**SEQUOYAH NUCLEAR PLANT - REVISION TO THE TECHNICAL REQUIREMENTS
MANUAL (TRM) (REVISIONS 8, 9, 10, 11, 12, AND 13)**

**SEQUOYAH NUCLEAR PLANT (SQN)
REVISION TO THE TECHNICAL REQUIREMENTS MANUAL (TRM)
(REVISIONS 8, 9, 10, 11, 12, AND 13)**

FIGURE 3.4-1
DOSE EQUIVALENT I-131 Primary Coolant Specific Activity Limit Versus
Percent of RATED THERMAL POWER with the Primary Coolant Specific
Activity > 0.25 μCi/gram Dose Equivalent I-131

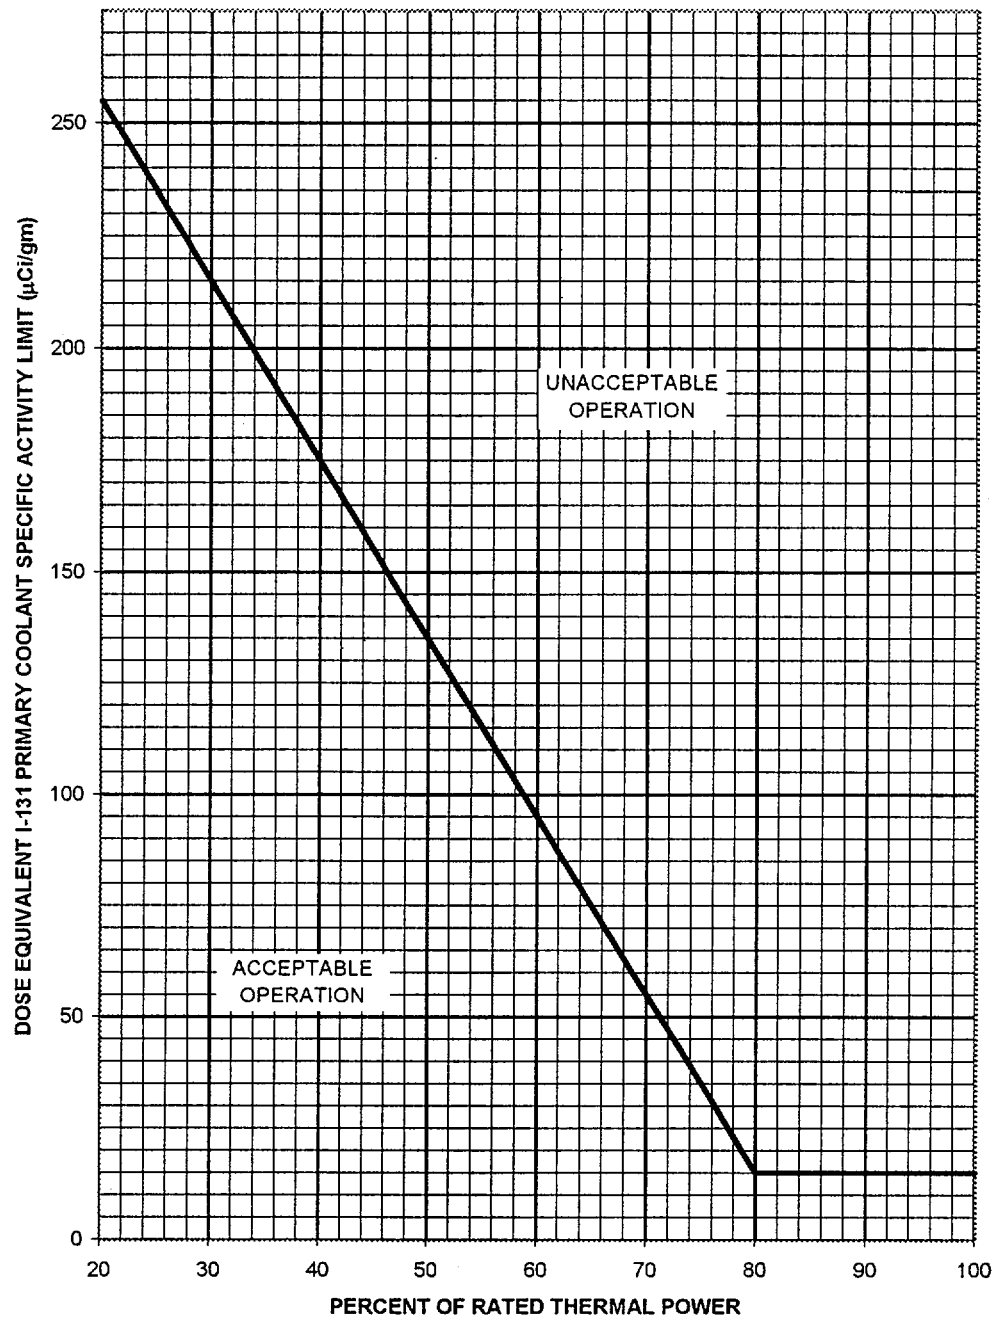
- a. With the specific activity of the primary coolant greater than **0.25** microcuries/gram DOSE EQUIVALENT I-131 for more than 48 hours during one continuous time interval or exceeding the limit line shown on Figure 3.4-1, be in at least HOT STANDBY with T_{avg} less than 500°F within 6 hours.
- b. With the specific activity of the primary coolant greater than $100/\bar{E}$ microcuries/gram, be in at least HOT STANDBY with T_{avg} less than 500°F within 6 hours.

The unbolded Specific Activity value and figure limits are more conservative than the Technical Specification requirements

FIGURE 3.1.2.6

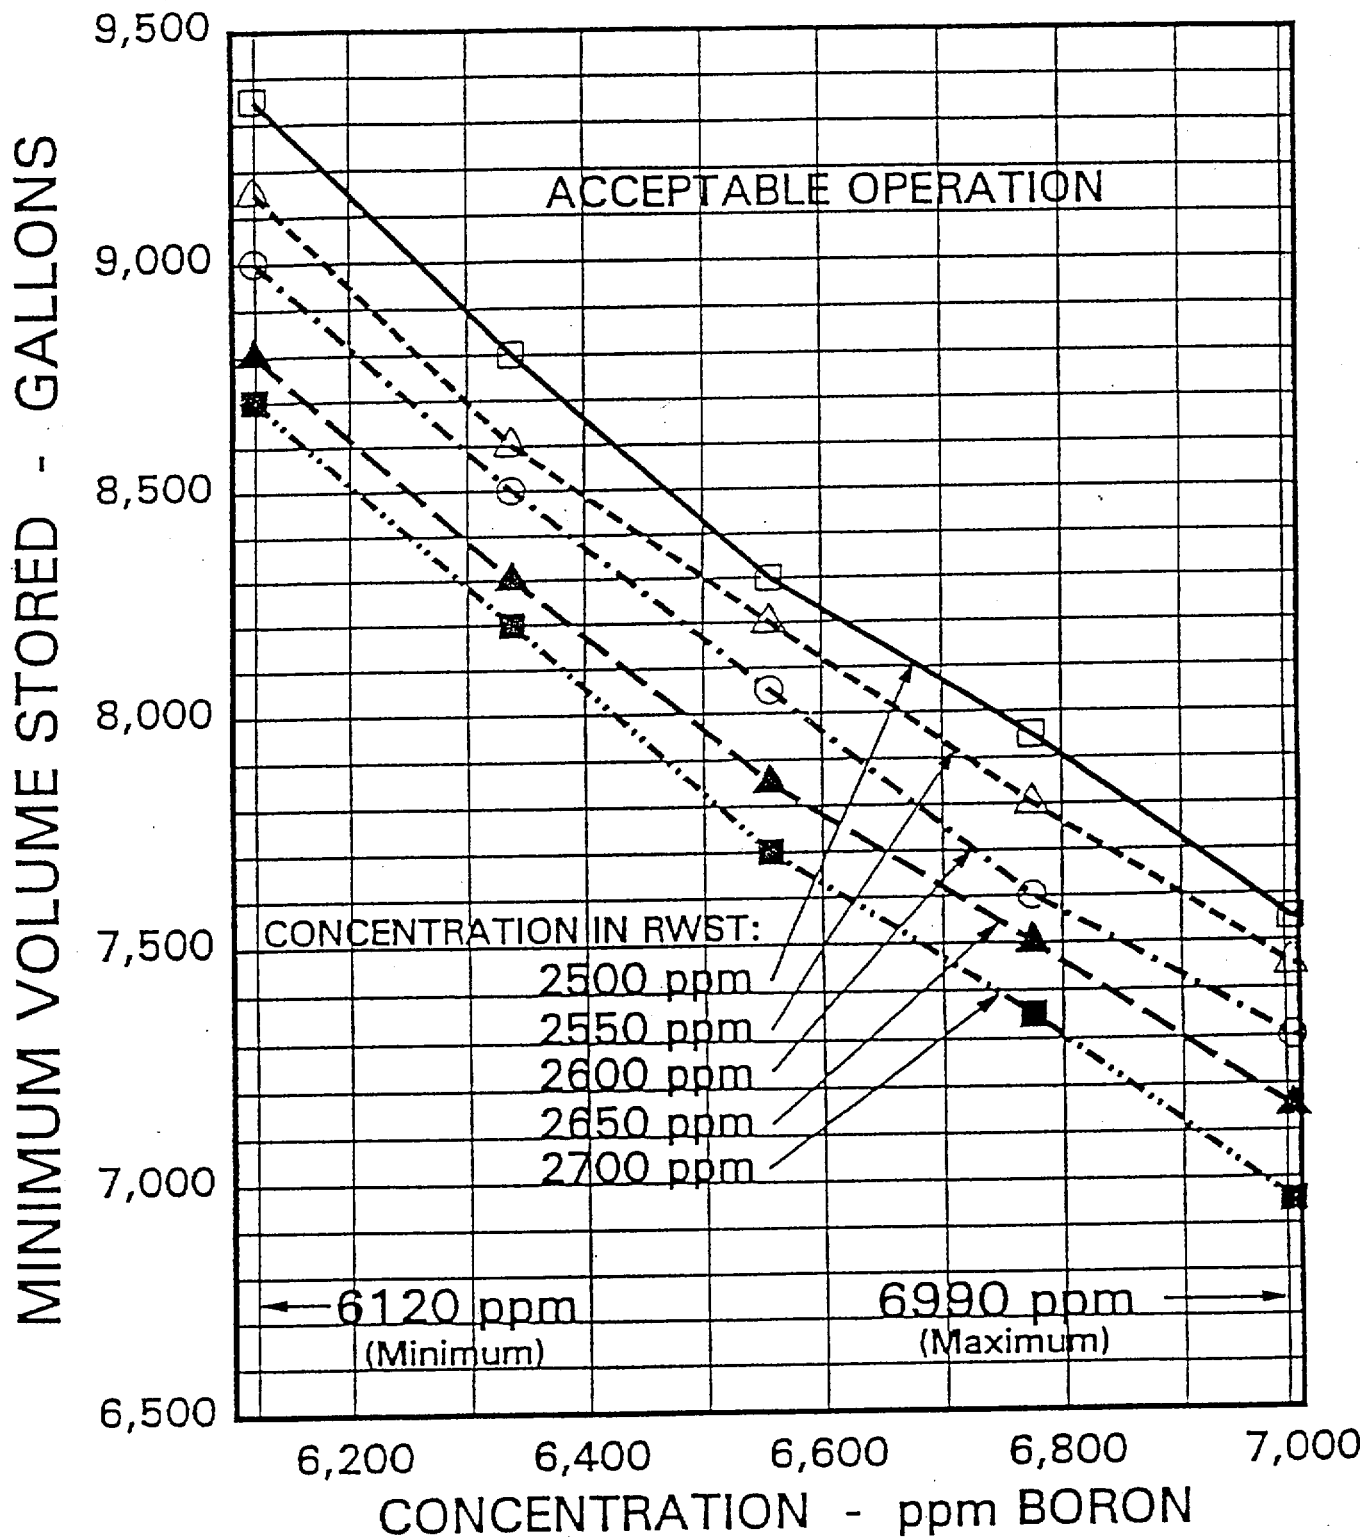
- a. A boric acid storage system with:
 - 1. A contained volume of borated water in accordance with Figure 3.1.2.6,
 - 2. A boron concentration in accordance with Figure 3.1.2.6, and
 - 3. A minimum solution temperature of 63°F.
- b. The refueling water storage tank with:
 - 1. A contained borated water volume of between 370,000 and 375,000 gallons,
 - 2. Between 2500 and 2700 ppm of boron,
 - 3. A minimum solution temperature of 60°F, and
 - 4. A maximum solution temperature of 105°F.
